Service Bulletin No. 118

SUBJECT: Battery Box Lid Modification

MODELS AFFECTED: PA-16 Airplanes with Serial Numbers 16-1 and up; PA-20 Airplanes with Serial Numbers 20-1 thru 20-802 inclusive; and PA-22 Airplanes with Serial Numbers 22-1 thru 22-348 inclusive.

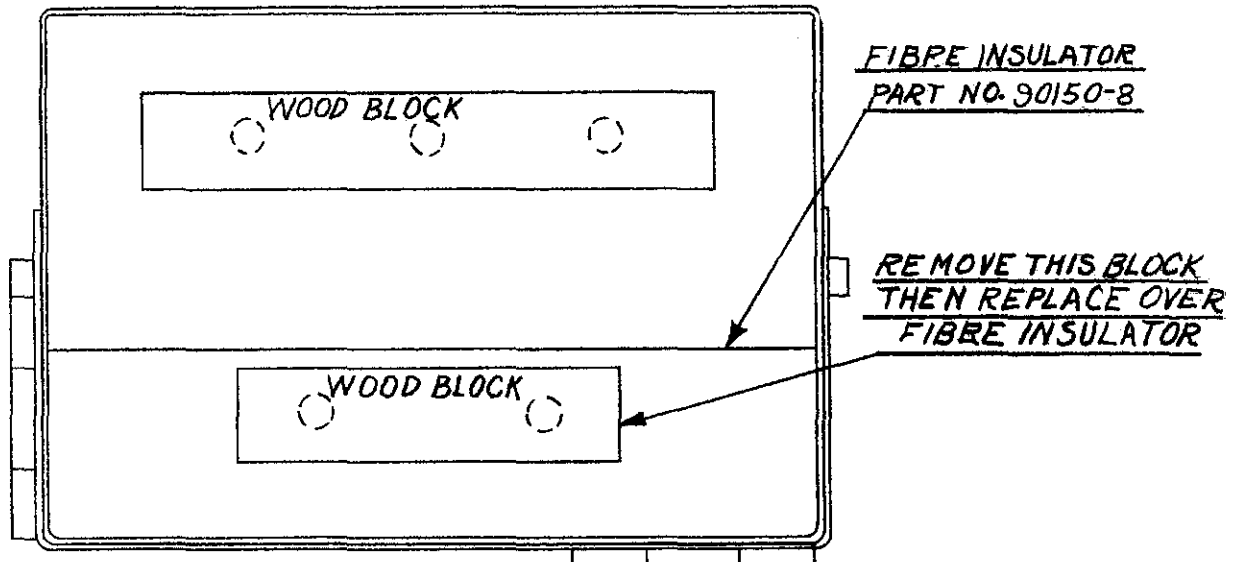
It is necessary that the battery box lids in the above listed airplanes be modified in accordance with the following instructions, to eliminate the possibility of "shorting" the battery terminal wing nuts.

Remove the wood block located between the battery cable openings. Place the fibre insulator, Piper Part Number 90150-8, inside the lid as shown in the following sketch. Replace the wood block using the same screws.
